**DOCUMENT 00 90 00
ADDENDUM**

ADDENDUM NO. [1] Date: February 16, 2021

**RE: WESTERN TECHNICAL COLLEGE
 SPARTA PUBLIC SAFETY EXPANSION
 11177 COUNTY HWY A
 SPARTA, WISCONSIN 54656
 HSR PROJECT NO. 20028**

FROM: HSR Associates, Inc
 100 Milwaukee Street
 La Crosse, WI 54603
 (608) 784-1830

M090

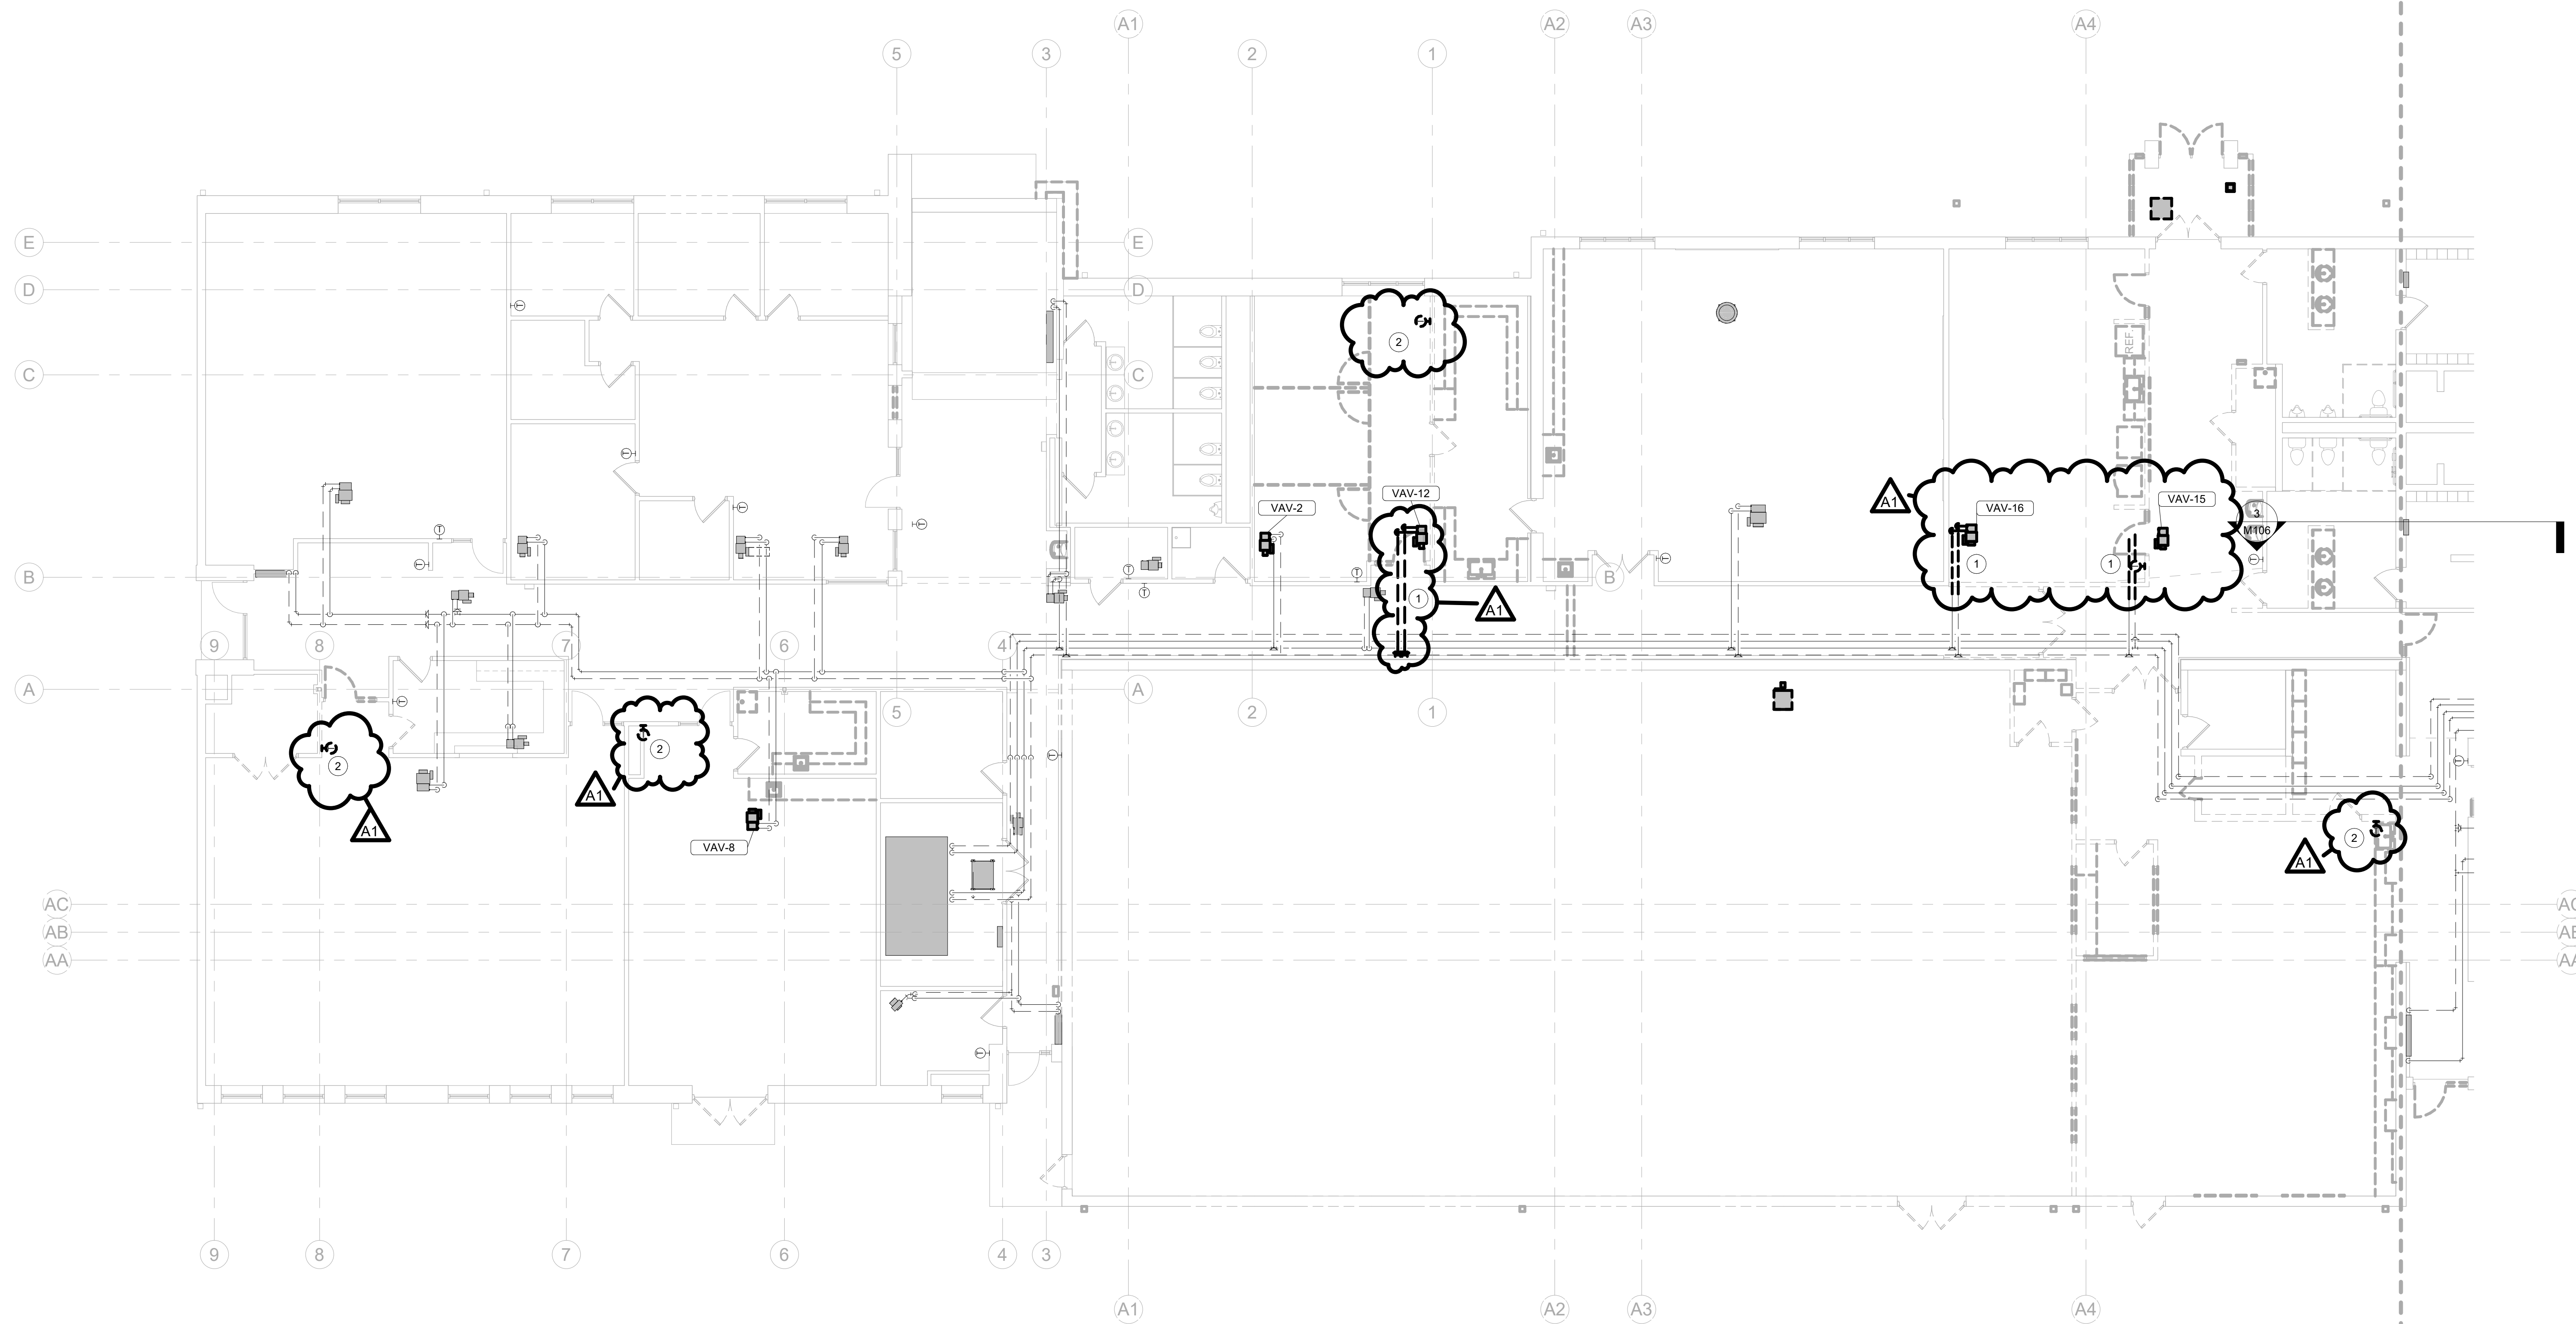
- a. Revisions clouded on Drawing
21. Sheet M090 FIRST FLOOR PIPING REMOVAL – A 30 x 42 attached hereto
 - a. Revisions clouded on Drawing
 - b. Added removal keyed notes.

- c. Added equipment tags.
22. Sheet M091 FIRST FLOOR PIPING REMOVAL – B 30 x 42 attached hereto
 - a. Revisions clouded on Drawing
 - b. Added removal keyed notes.

3 MECH RM 2M3 & 2M4 - REMOVAL

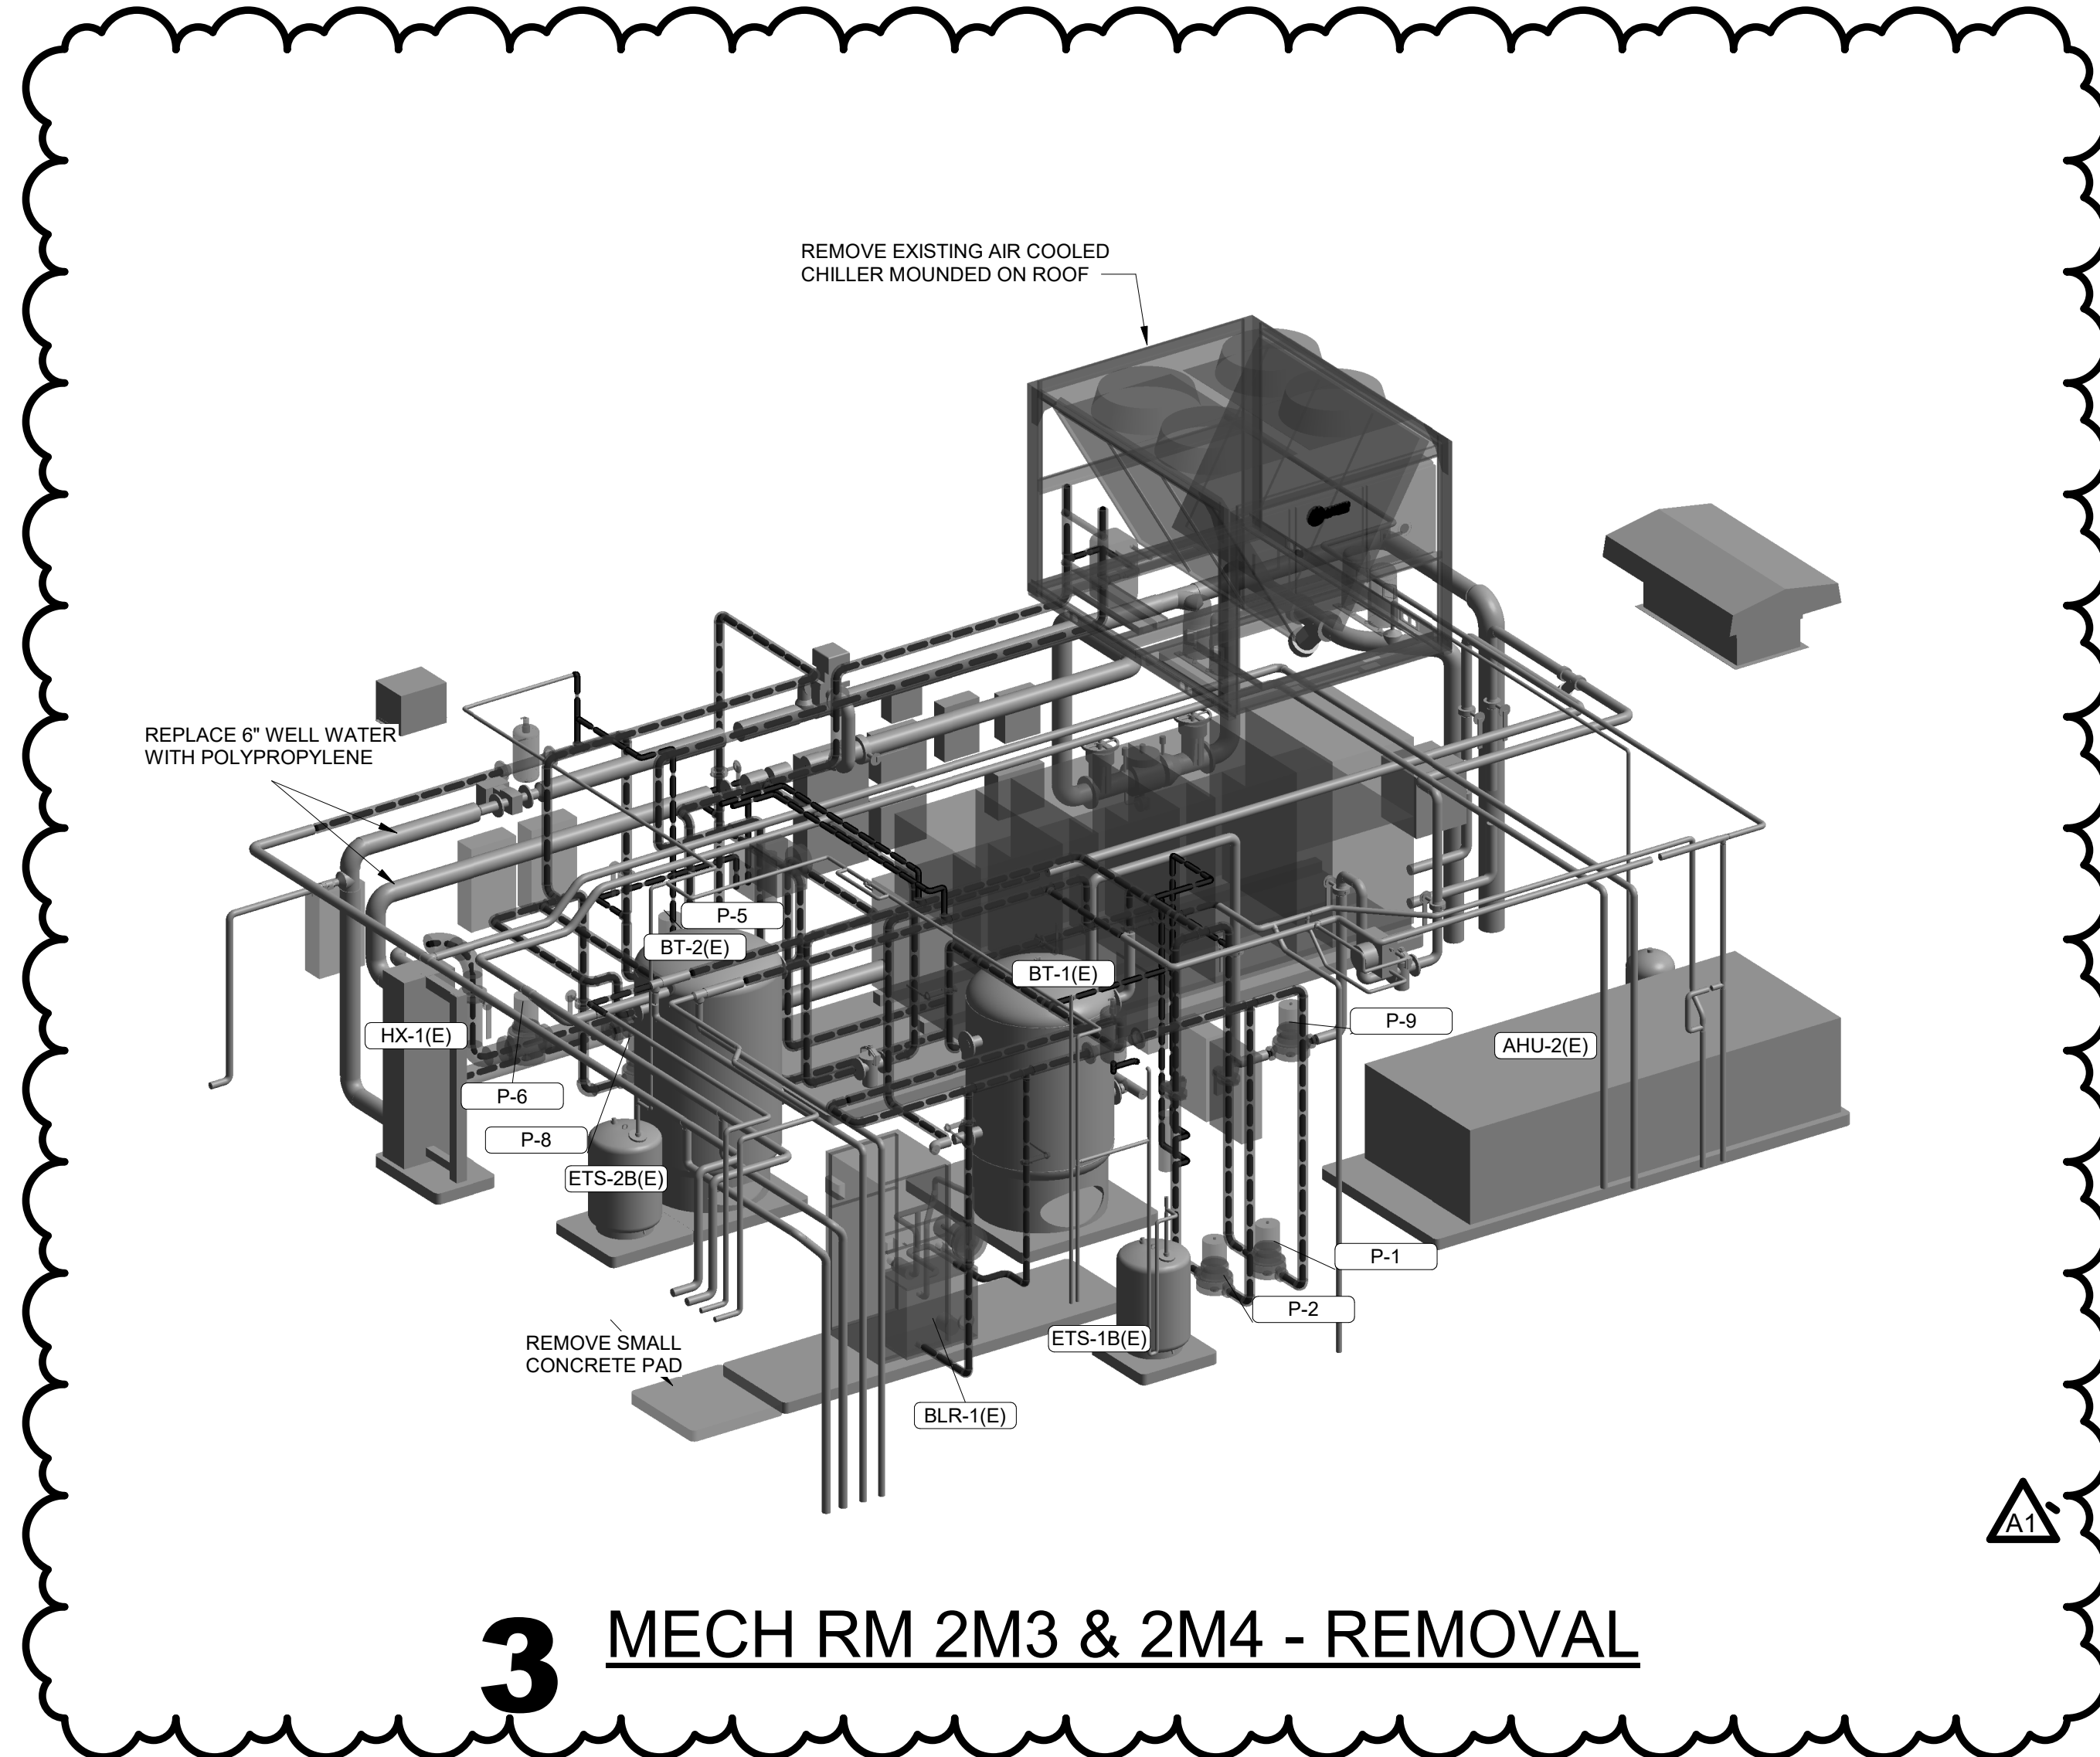
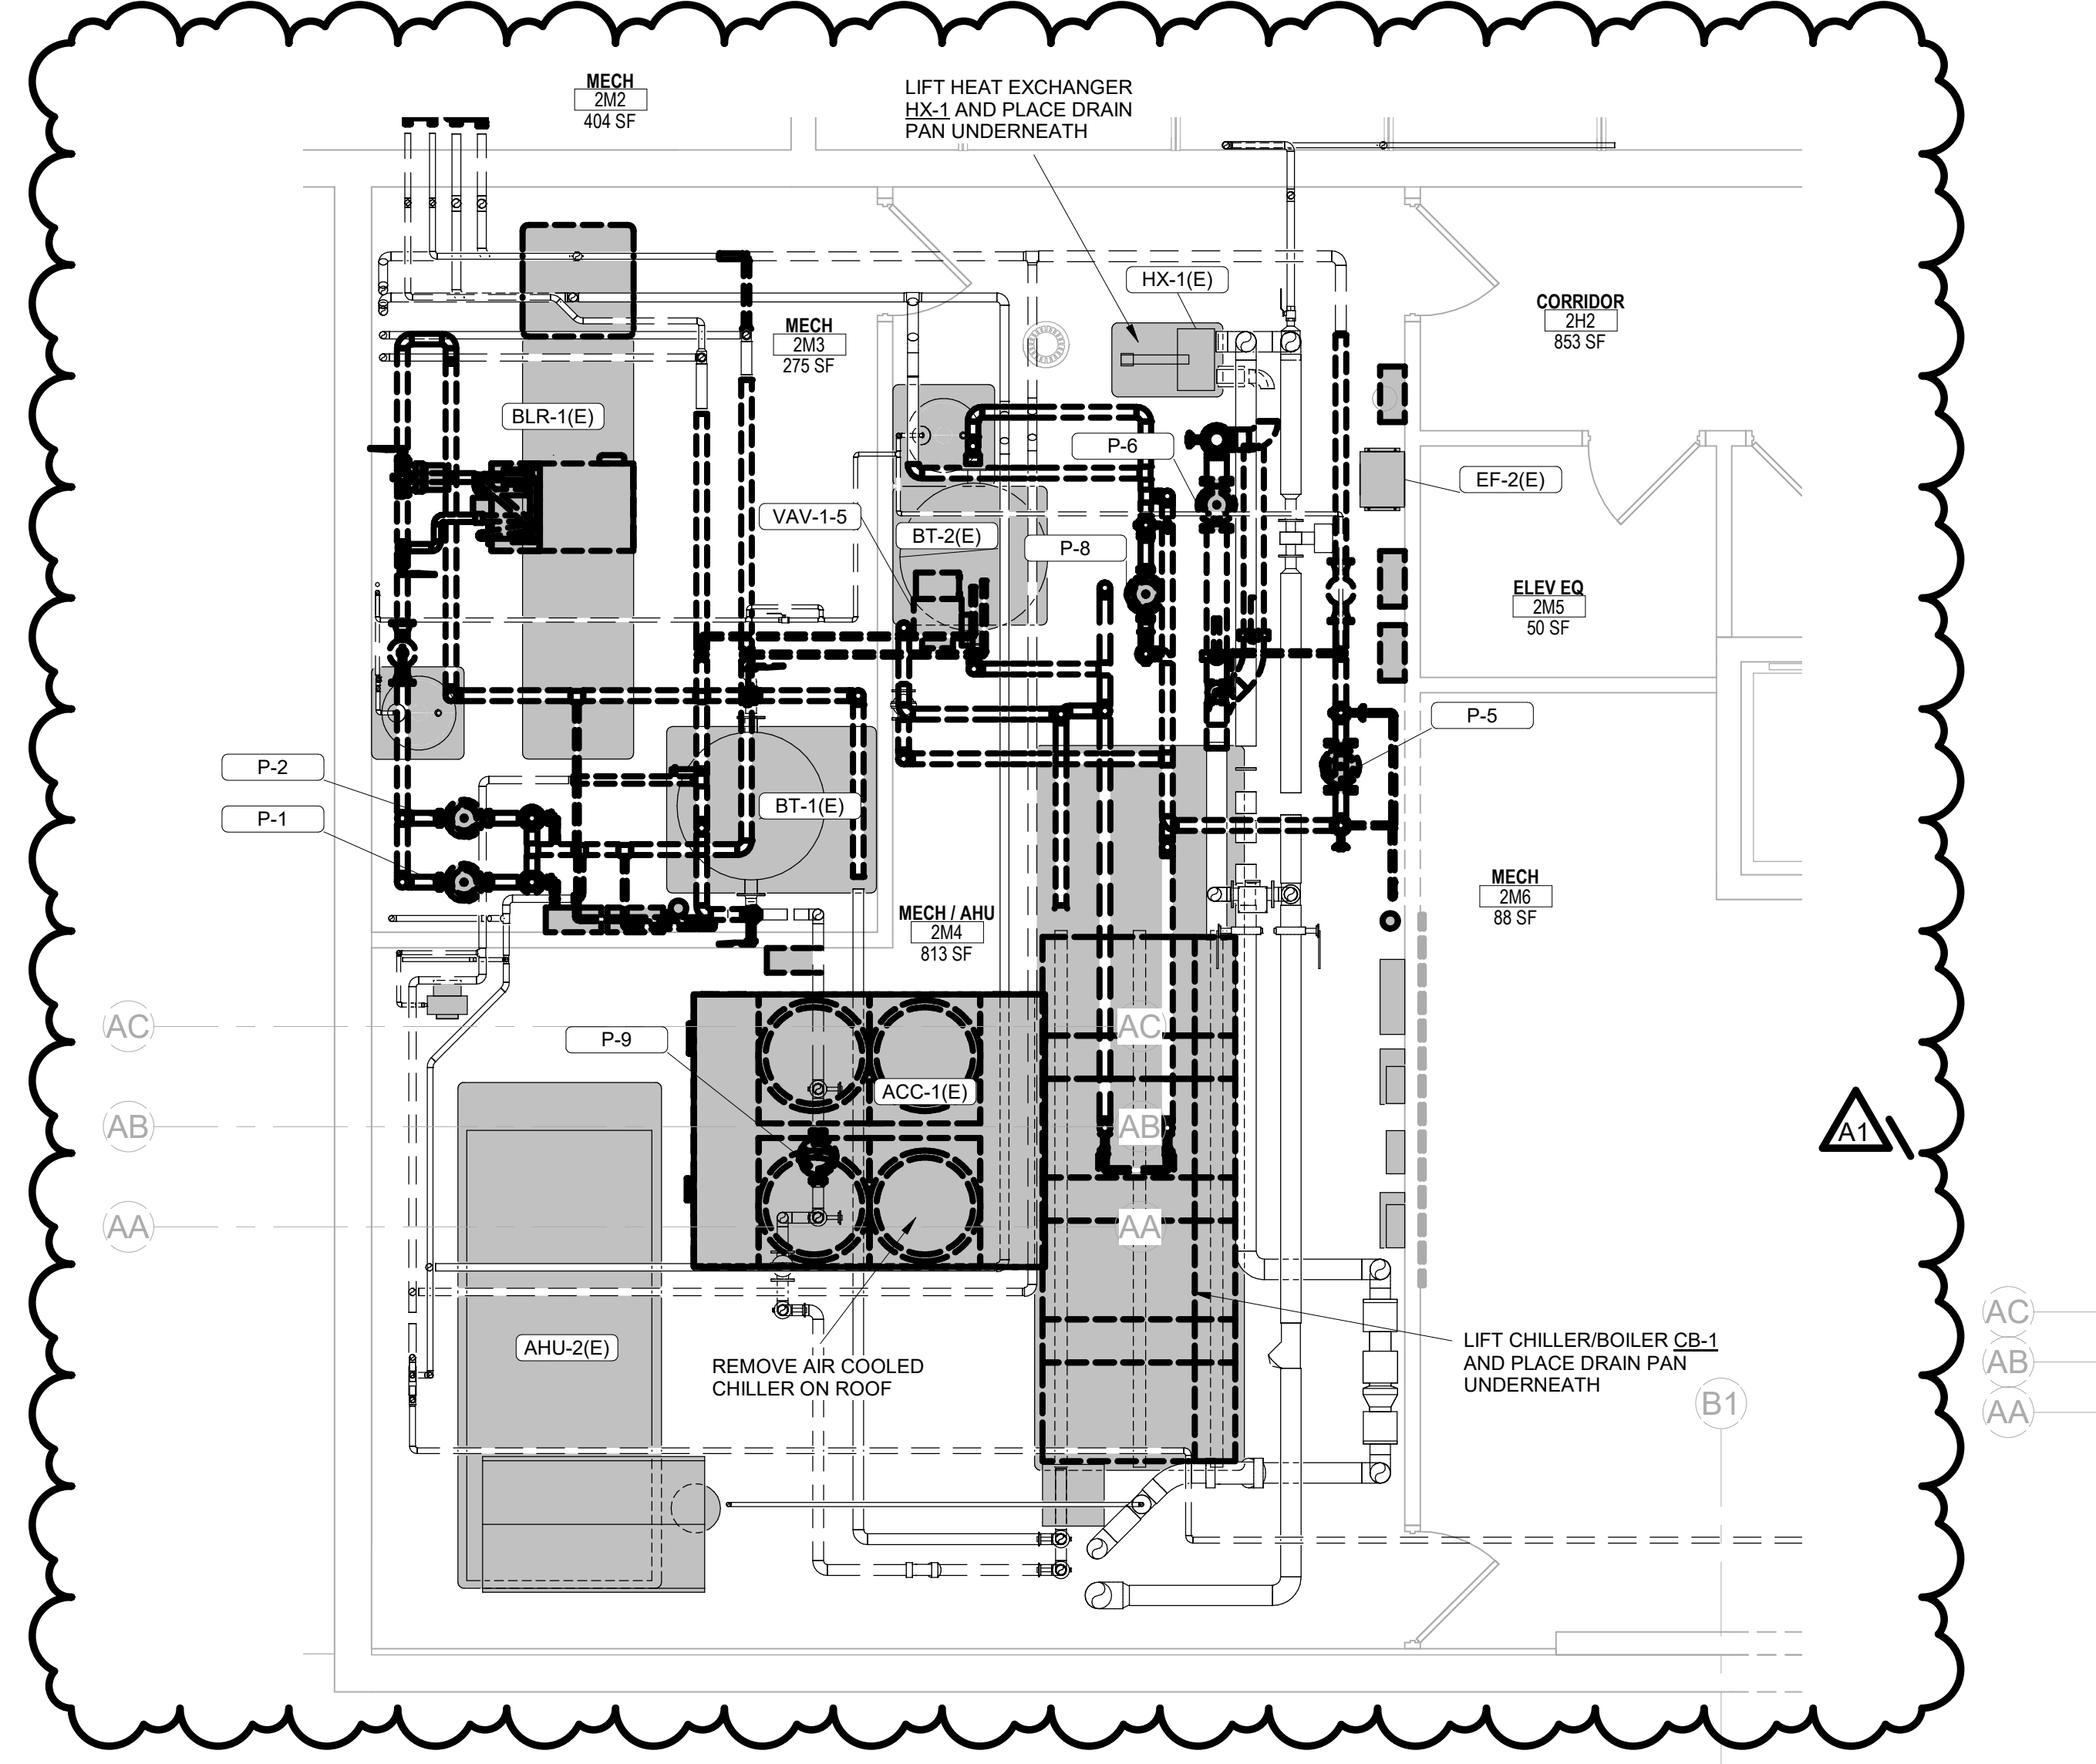
- c. Added equipment tags.
23. Sheet M092 SECOND FLOOR PIPING REMOVAL 30 x 42 attached hereto
 - a. Revisions clouded on Drawing
 - b. Added removal notes.

- c. Added Mechanical Room 2M3 & 2M4 3D View.
24. Sheet M100 FIRST FLOOR PIPING REMODEL – A 30 x 42 attached hereto
 - a. Revisions clouded on Drawing
 - b. Added room names.
